UNITED STATES PATENT AND TRADEMARK OFFICE

Office Action Summary

10/516,961

DETAILED ACTION

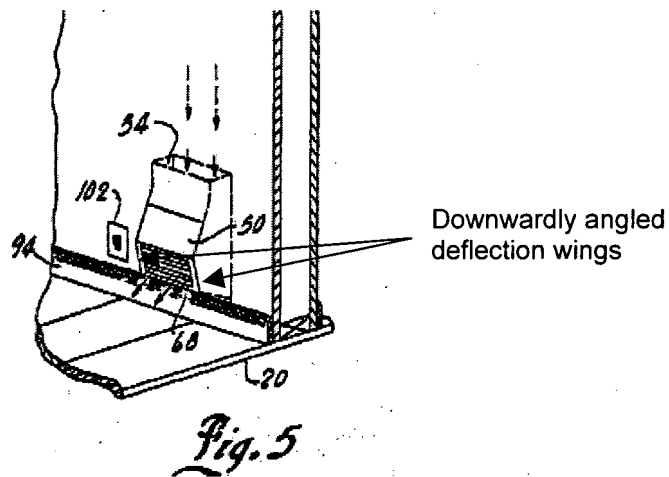
Regarding claims 16-17 and 23-24, Wolbrink illustrates in Figure 5 (modified Figure shown below) the wall panel (100) of claim 15 wherein the heat/air deflector (68) comprises two downwardly angled deflection wings.

The examiner notes that the heat/air deflector would be removable from the channel by one of routine skill in the art using simple tools.
